FINAL MITIGATION PLAN

BANNER FARM MITIGATION SITE

Henderson County, NC
NCDEQ Contract No. 7530
DMS ID No. 100062

Re: NCIRT Review and USACE Approval of the NCDMS Banner Farm Mitigation Site /
Henderson Co./ SAW-2018-01153/ NCDMS Project # 100062

2.1.4
 Sheet

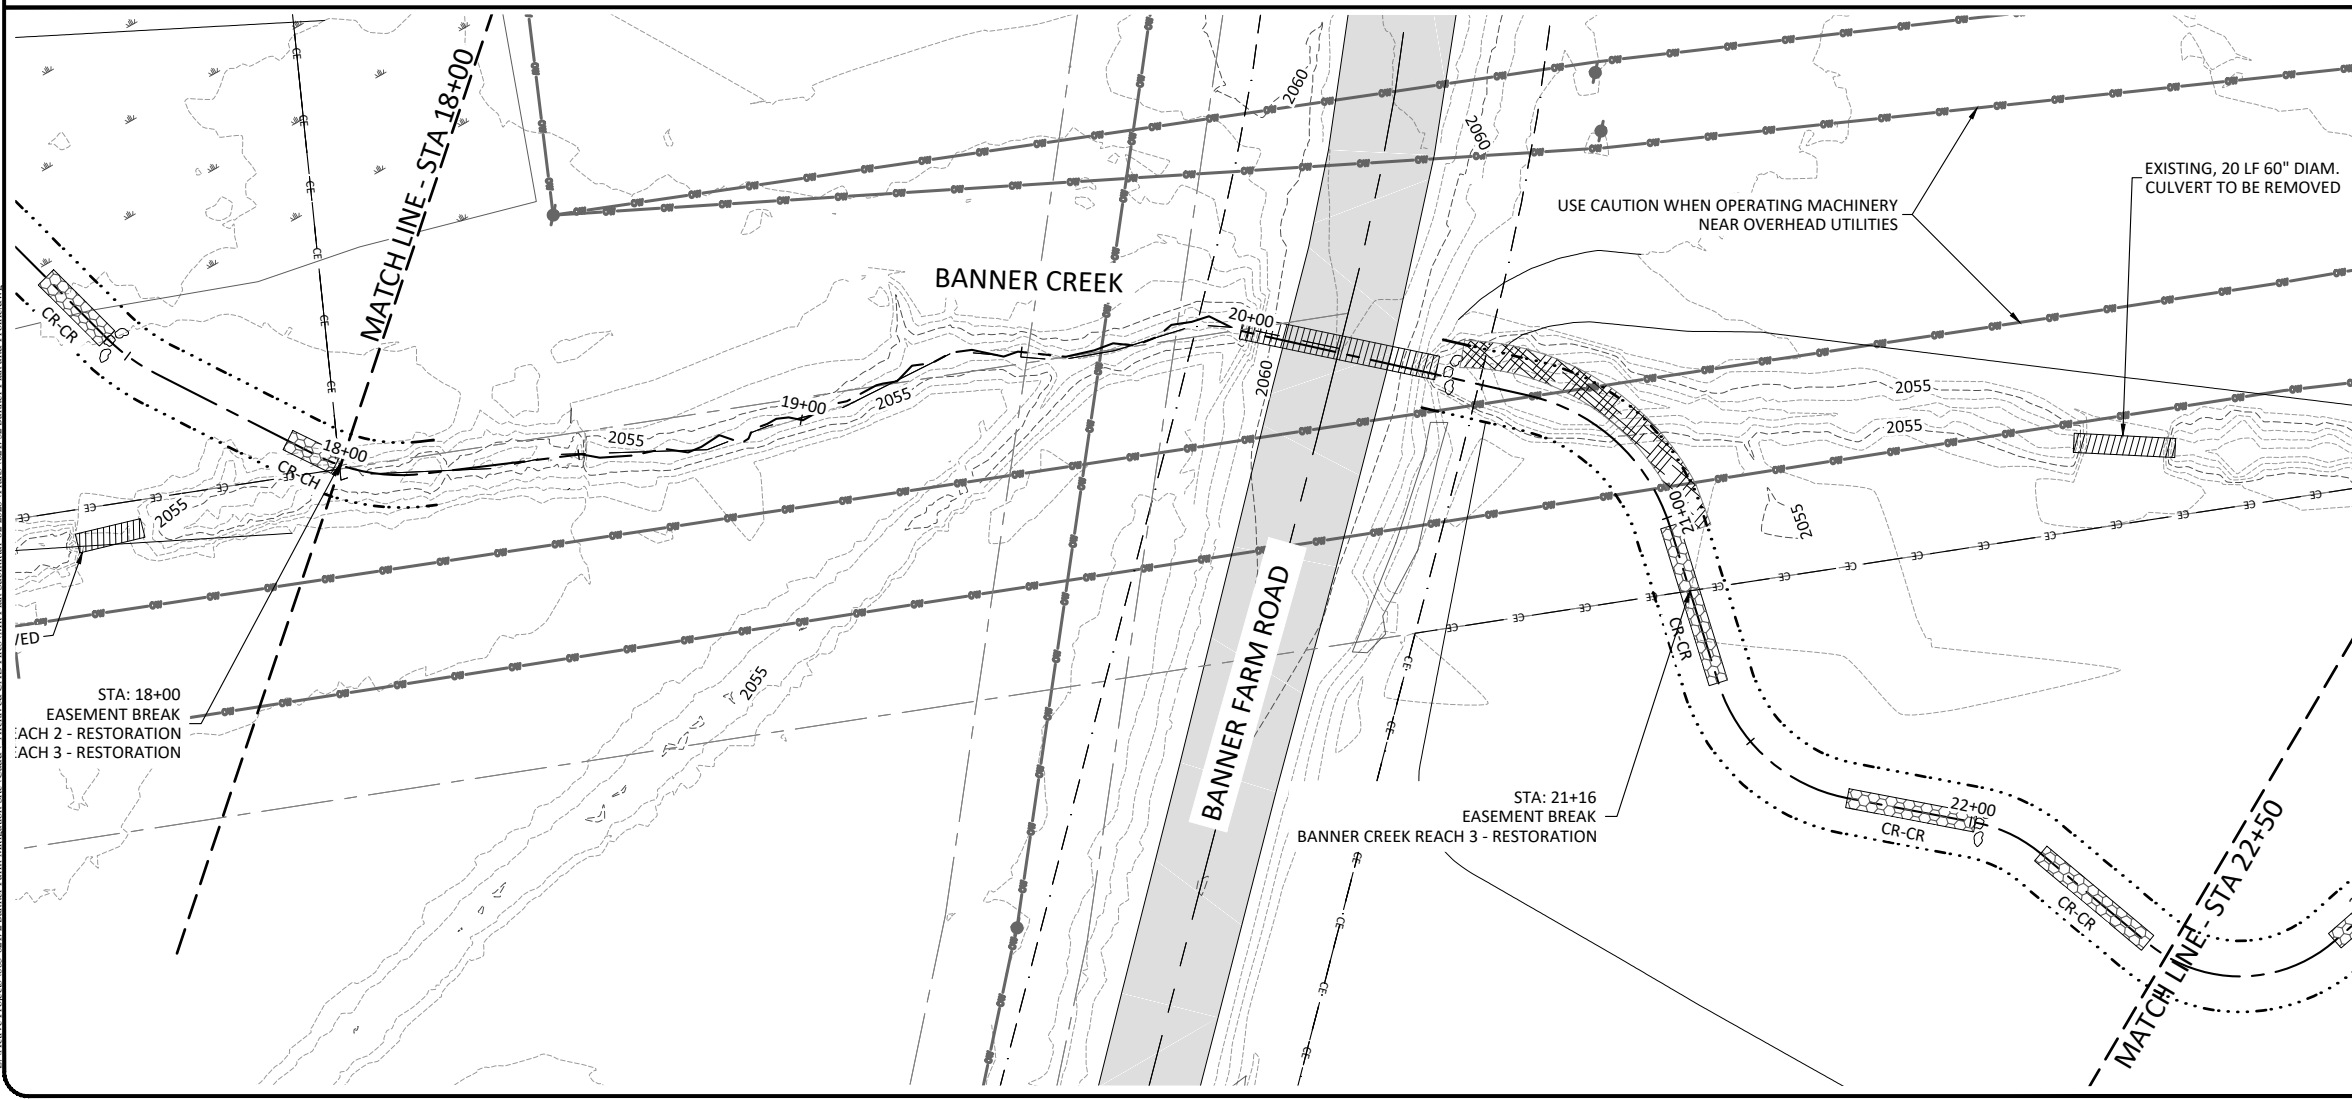
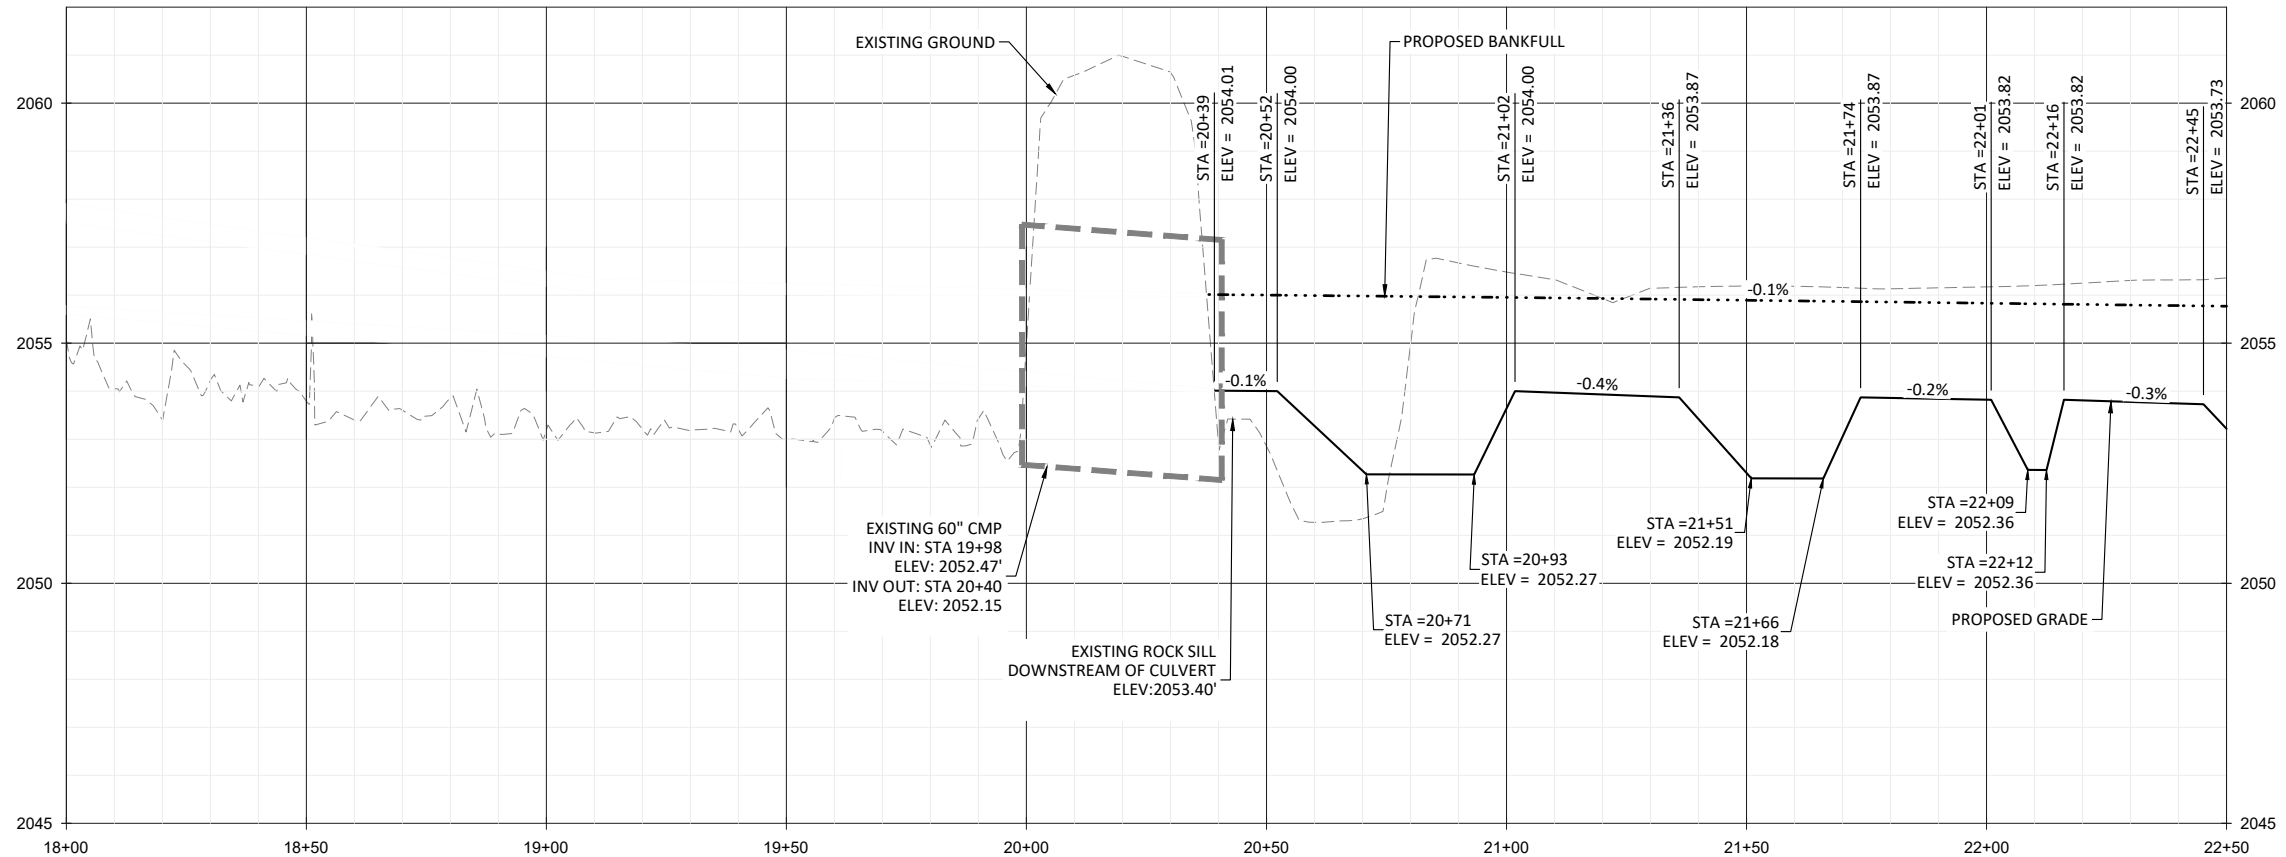
- c. Sheet 2.1.4 – There appears to be an existing stormwater pipe that discharges within the proposed easement. Please confirm that this structure will be removed.

c. Sheet 2.1.4 – There appears to be an existing stormwater pipe that discharges within the proposed easement. Please confirm that this structure will be removed.

The existing stormwater pipe shown on Sheet 2.1.4 will be removed from the proposed conservation easement. A note was added to the sheet that reads “Excavate and remove stormwater pipes from easement”

As shown in the plans on Sheet 2.1.4, Banner Creek Reach 3 begins at Station 18+00 and an easement break also begins at Station 18+00. Sheet 2.1.5 shows the end of the easement break at Station 21+16 and this is the station where the credited length of Reach 3 begins. The end of Reach 3 is located on Sheet 2.1.6 at Station 25+83. The total length of Reach 3 is 783 ft; however, the credited length is 467 ft as shown in Table 21 (Asset Table) of the Mitigation Plan.
